Rebuttal Proof of Evidence – Arboriculture Drawings and Appendices

Brislington Meadows, Bristol
PINS Ref. APP/Z0116/W/22/3308537

Brislington Meadows - Review of FLAC Proof of Evidence – Hedgerow Age

CANDIDATE VETERAN TREE HABITAT CONDITION ASSESSMENT SUMMARY

Drawing Number
D7507.43.003.VH5

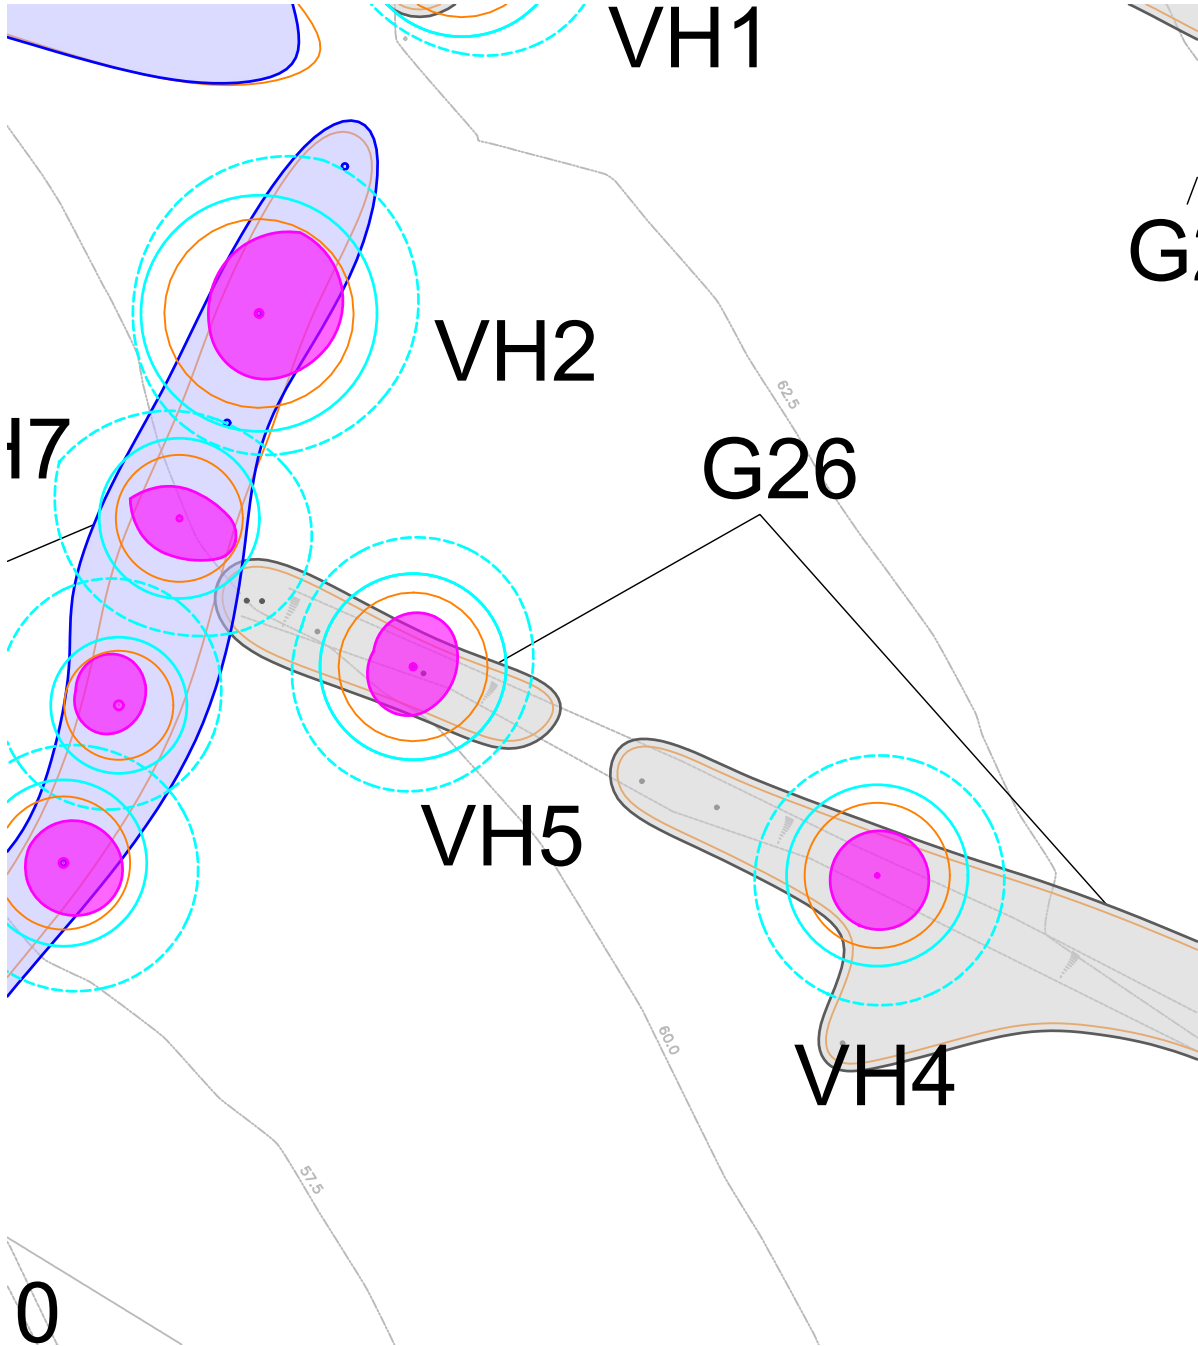
5. FLAC Claimed 'Primary Features'
- Extensive decay
 - Not agreed. One decaying stub at 1.8m but not brown rot. Exposed sunken patch on stem indicating underlying dysfunction and necrosis but with bark remaining and no decay.
6. FLAC Claimed 'Secondary Features'
- Lichens present in significant quantities
 - Not agreed. Limited to one patch on main stem of c.40cm x 12cm. Not a significant quantity.

Only 1 criteria claimed. Therefore not a veteran tree on grounds of condition.

Drawing Number
D7507.43.003.VH6

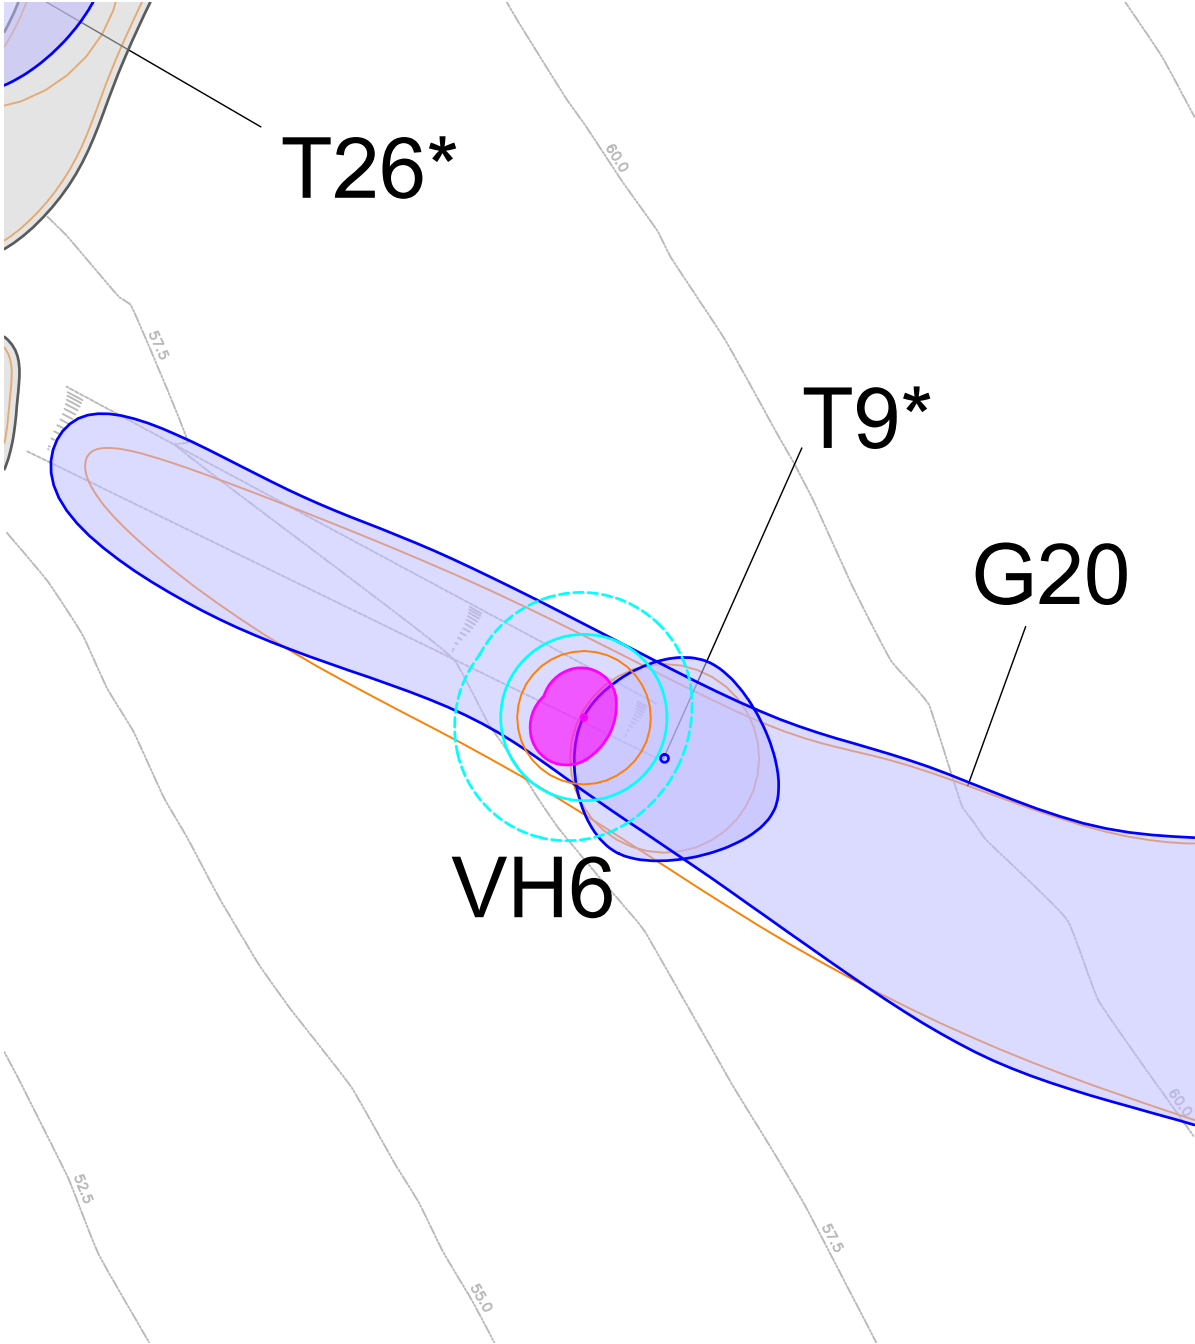
5. FLAC Claimed 'Primary Features'
- Extensive decay
 - Weak positive. Only possible to achieve figure by aggregating all very small wounds at previous hedging points. 50, 70 and 110mm diameter areas, and three other patches of 90x300, 50x150, and 50x100mm. Cumulative, but none large or significant. Limited penetration.
6. FLAC Claimed 'Secondary Features'
- Fungi, especially where present in numbers
 - Not agreed. *Stereum* fungi on one or two branches only. Widespread and very common species. Very small patch of surface mould on wet leaves.
 - Lichens present in significant quantities
 - Not agreed. Small area at base contains patch of lichen but very limited extent.

Only 2 criteria claimed. Therefore not a veteran tree on grounds of condition.

Drawing Number
D7507.43.003.VH7

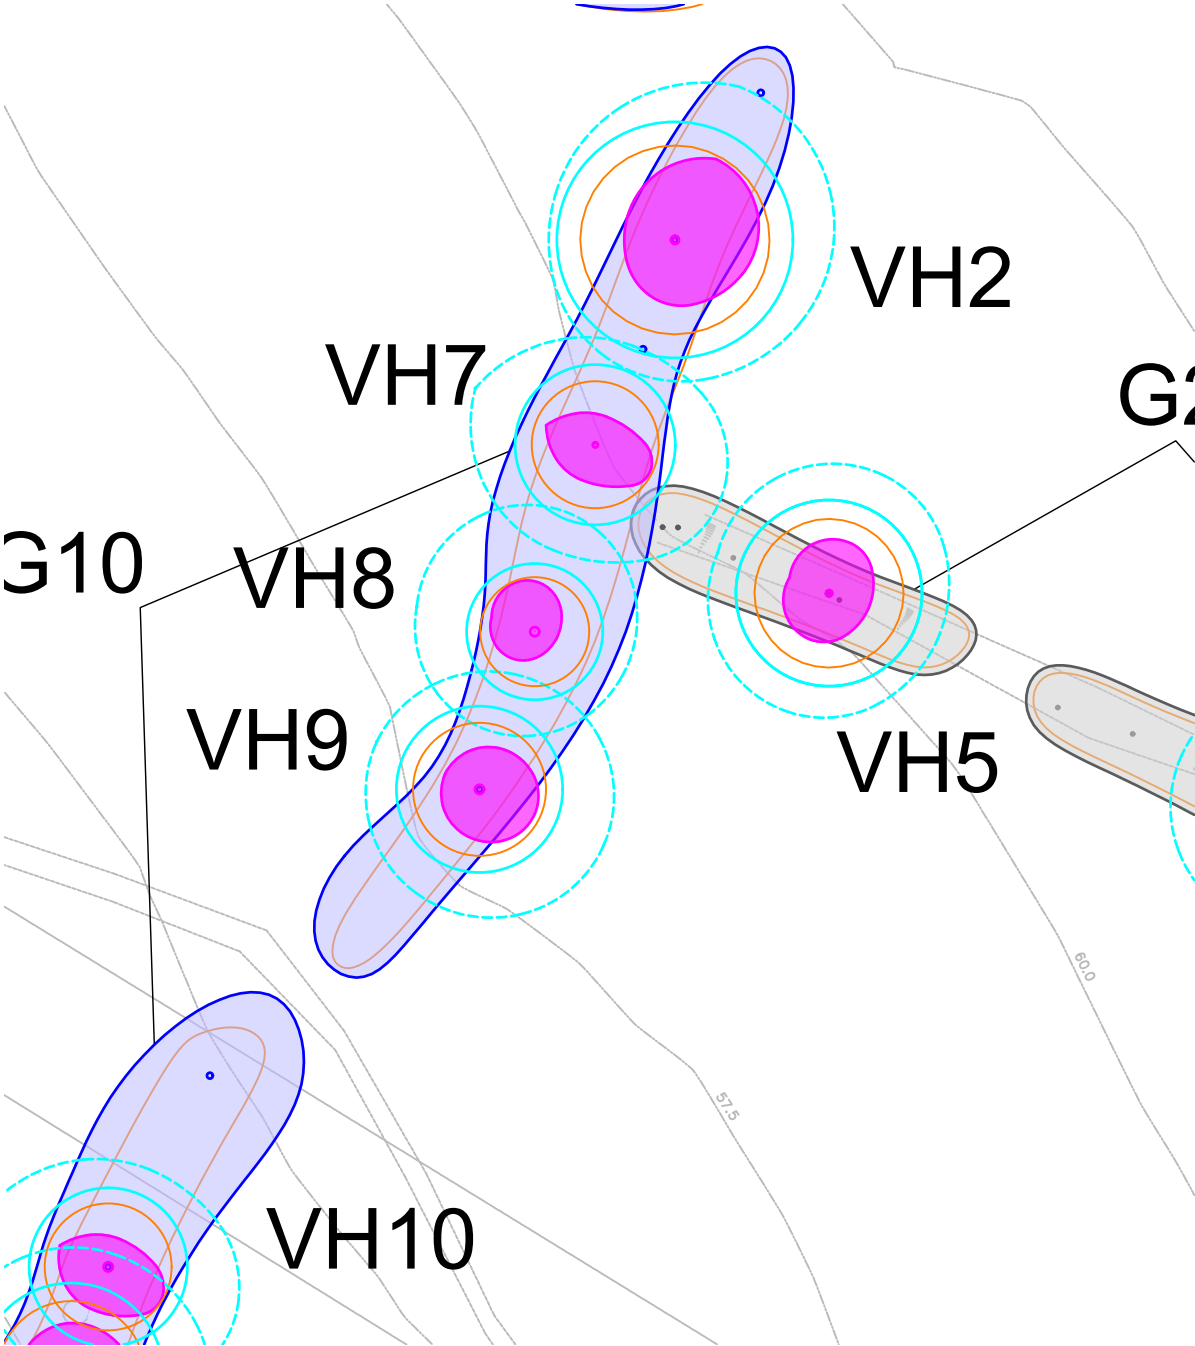
- 5. **FLAC Claimed 'Primary Features'**
 - Extensive decay
 - Agreed. Area in base of one stem is 600x150mm
 - Significant hollowing
 - Weak positive. There is hollowing, but this is the same feature as the 'extensive decay'. Double counting.
 - Significant retrenchment
 - Not agreed. Possible conflation with adjacent elder
- 6. **FLAC Claimed 'Secondary Features'**
 - Fungi, especially where present in numbers
 - None noted. Perhaps inferred from stem decay (i.e. same feature as 'extensive decay' and 'hollowing').
 - Lichens present in significant quantities
 - Not agreed. Very limited.

Only 3 criteria claimed. Therefore not a veteran tree on grounds of condition.

Drawing Number
D7507.43.003.VH8

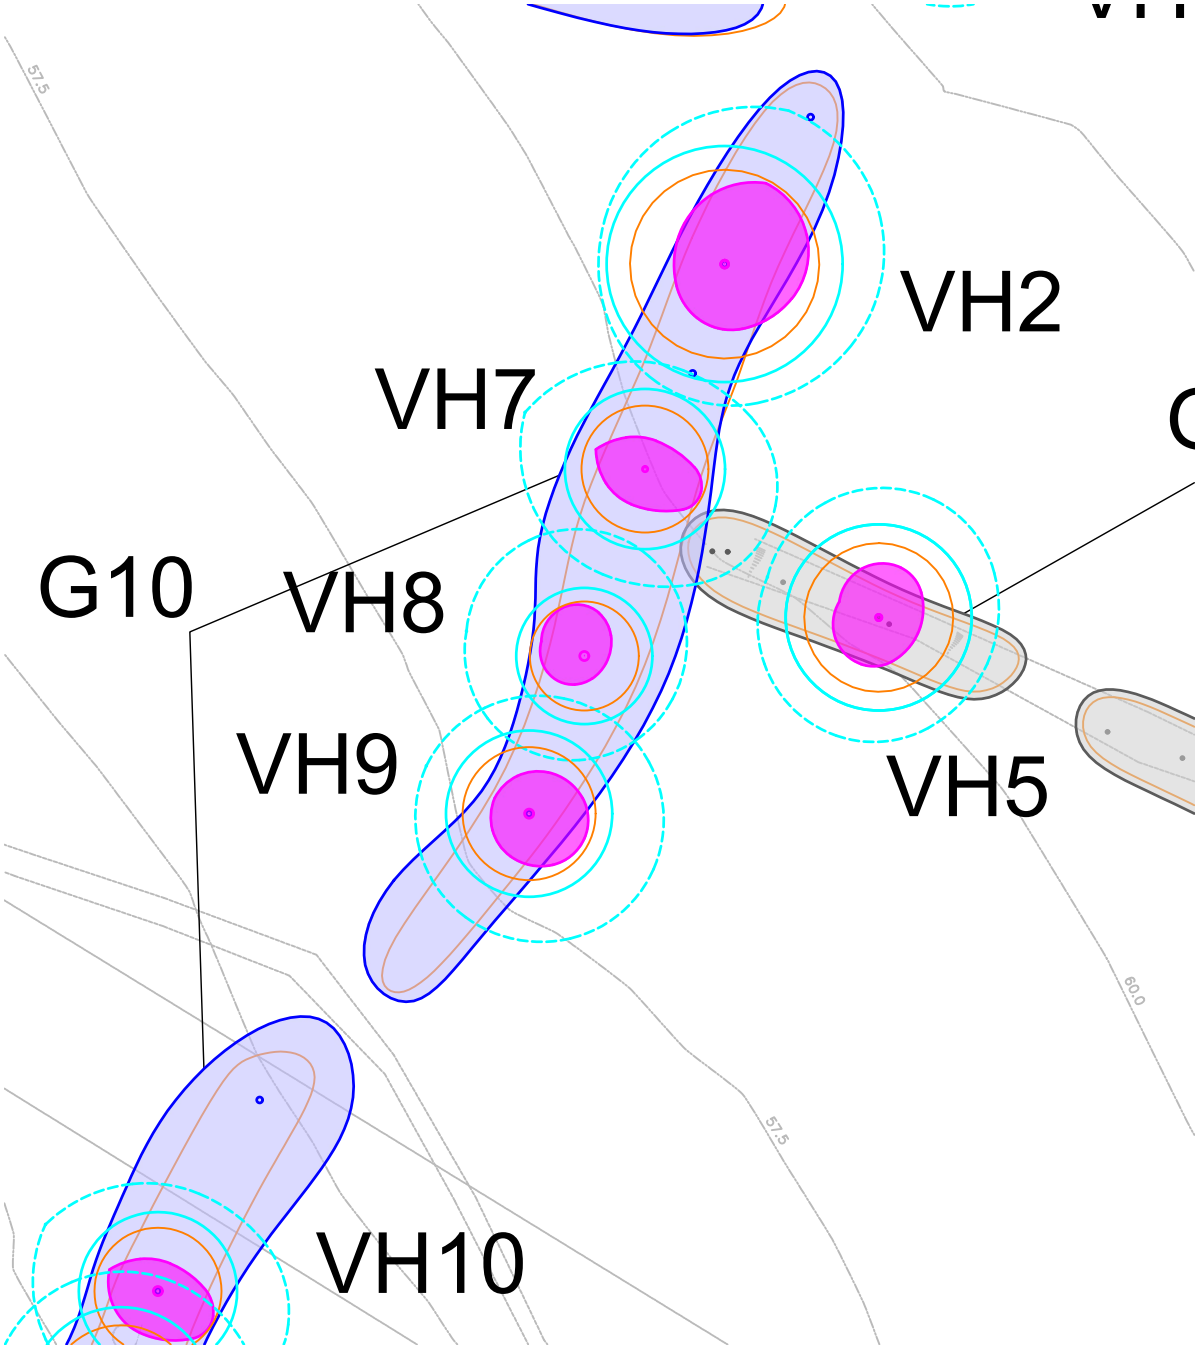
- 5. FLAC Claimed 'Primary Features'
 - Extensive decay
 - Agreed. Within primary union failure.
 - Not agreed. Progressive union failure with shallow decay of expose surfaces only.
 - Significant hollowing
 - Not agreed. Early retrenchment only, not significantly progressed.
 - Significant retrenchment
 - Not agreed. Early retrenchment only, not significantly progressed.
- 6. FLAC Claimed 'Secondary Features'
 - Dead wood>150mm diameter, especially where present in numbers
 - Not agreed. Largest diameter is 90mm. Large branch has fallen off and is no longer connected to the tree.
 - Lichens present in significant quantities
 - Not agreed. Small patches only.

Only 3 criteria claimed. Therefore not a veteran tree on grounds of condition.

Description of Tree - VH9

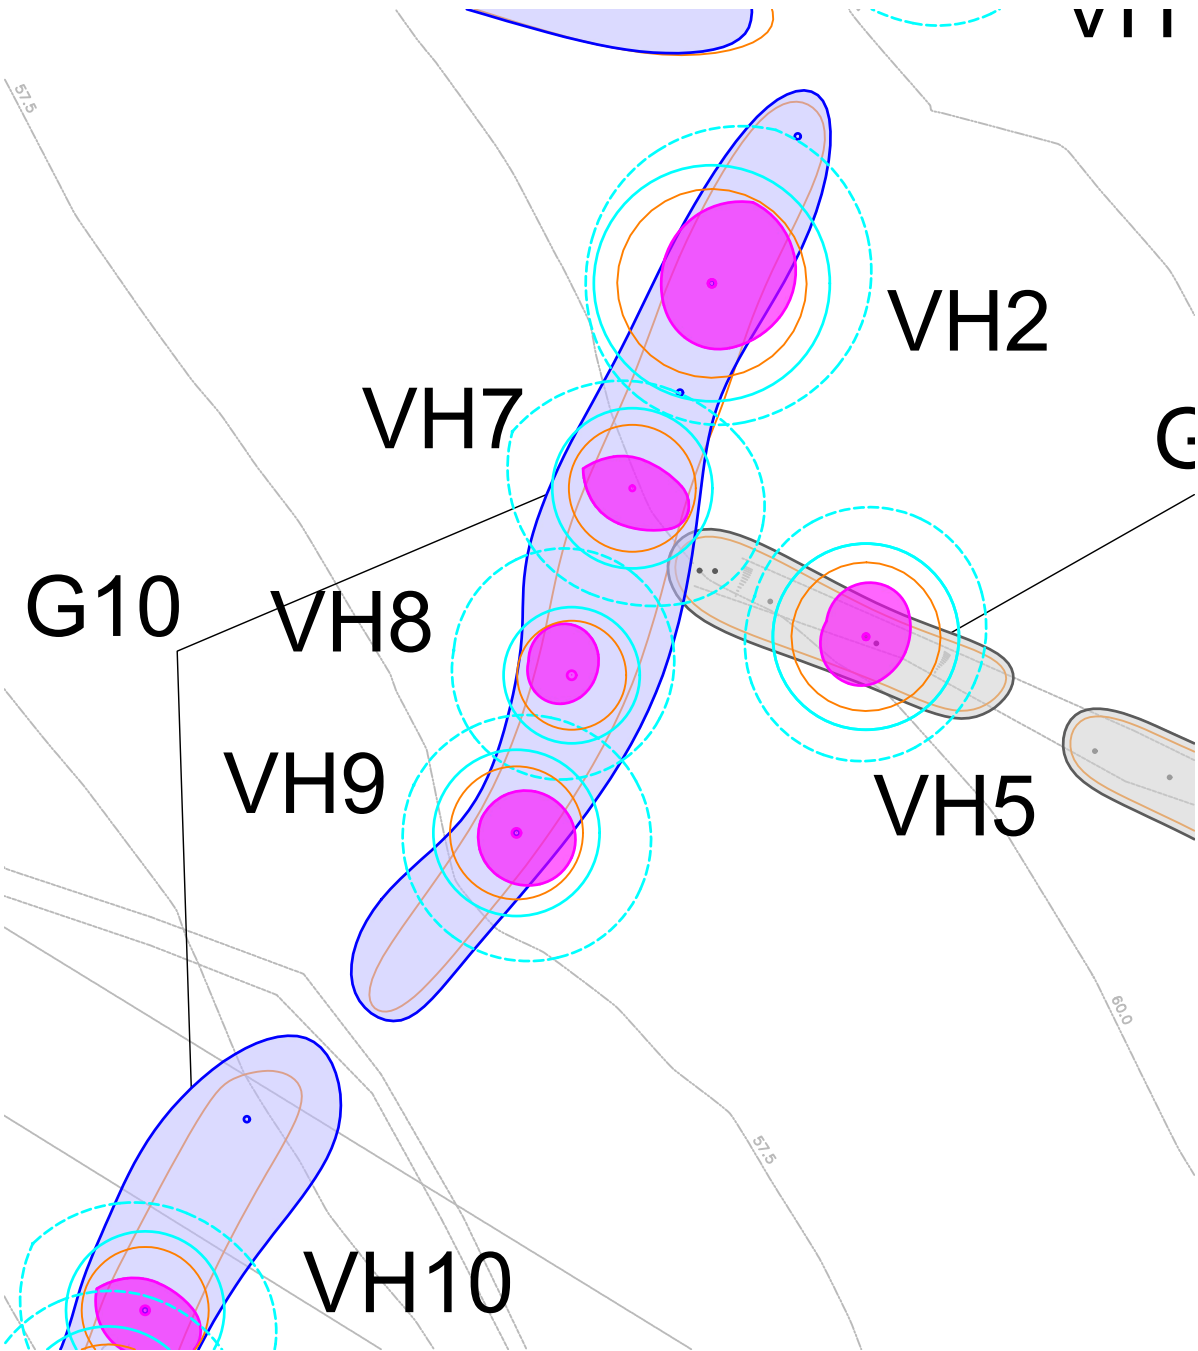
Weak positive. Cumulative assessment including small rotting stem may reach threshold. Agreed in the interests of a cautious assessment.
- Significant retrenchment

Not agreed. Early retrenchment only. Not significantly progressed.
6. FLAC Claimed 'Secondary Features'
- Fungi, especially where present in numbers

None apparent. Decay very limited.
- Lichens present in significant quantities

One patch. No significant quantity.

Drawing Number
D7507.43.003.VH10

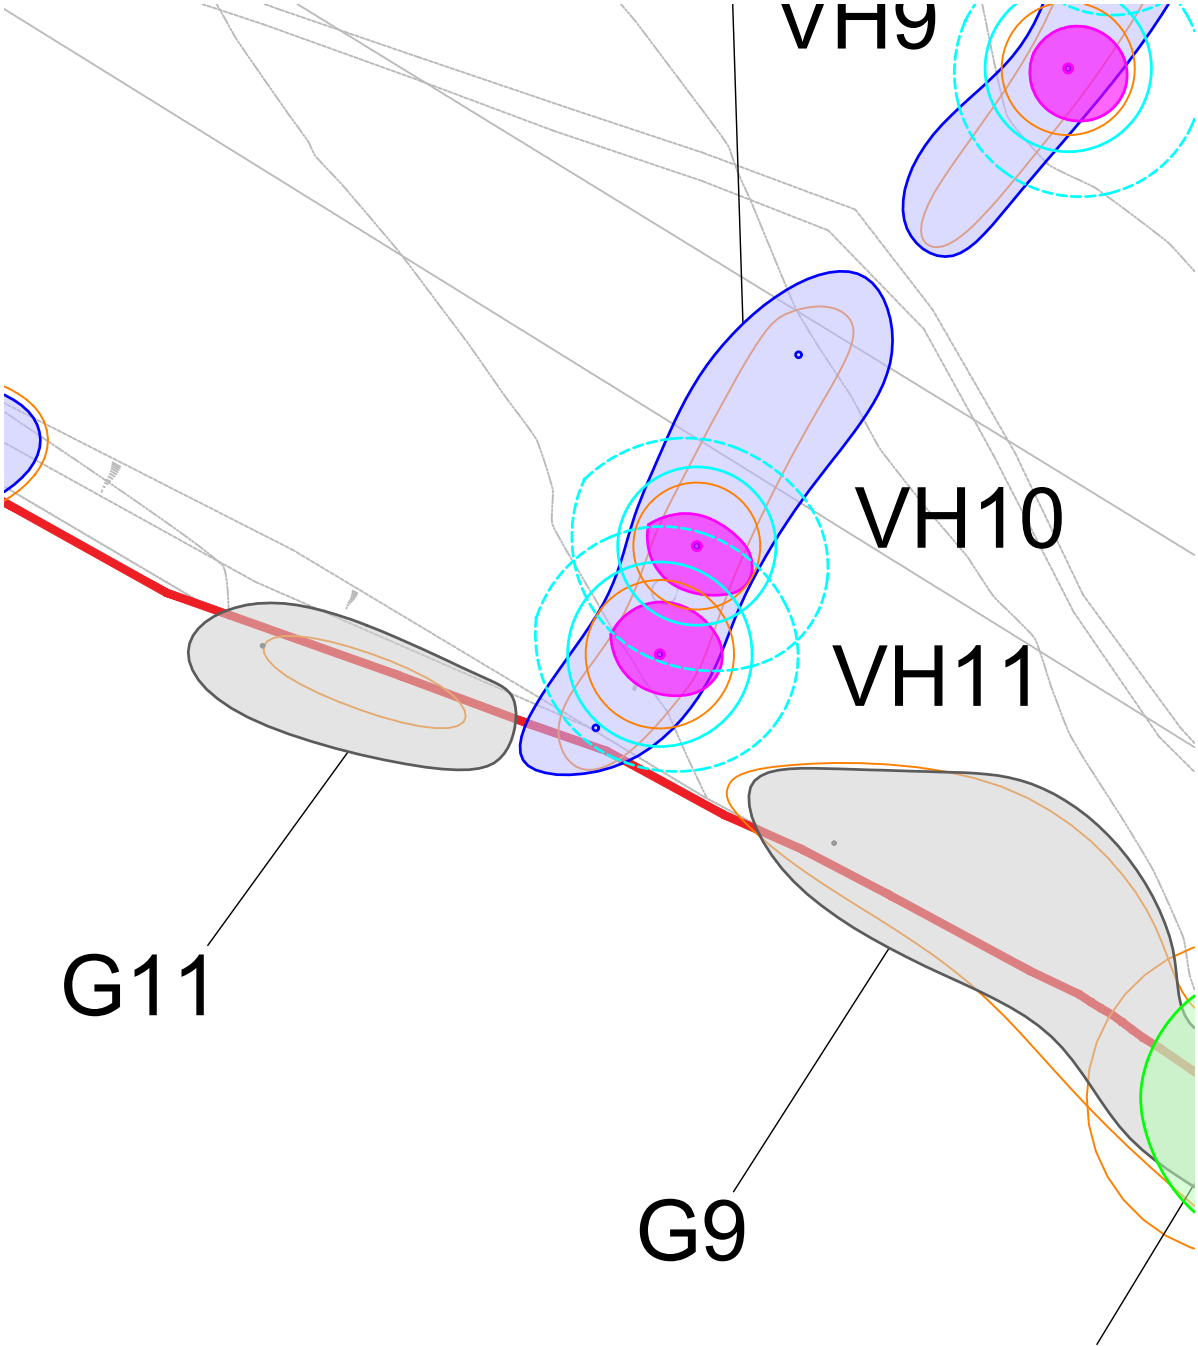
Agreed
- Significant hollowing

Not agreed. Gap is principally space between stems that are progressively failing and have surface decay.
- Significant retrenchment

Not agreed. Growth is slowing down and tree carries small diameter dead wood. But it retains good vigour and has no internal crown or stag heading. No significant retrenchment.
6. FLAC Claimed 'Secondary Features'
- Lichens present in significant quantities

Not agreed. Basis for claim unclear.

Only 2 criteria claimed. Therefore not a veteran tree on grounds of condition.
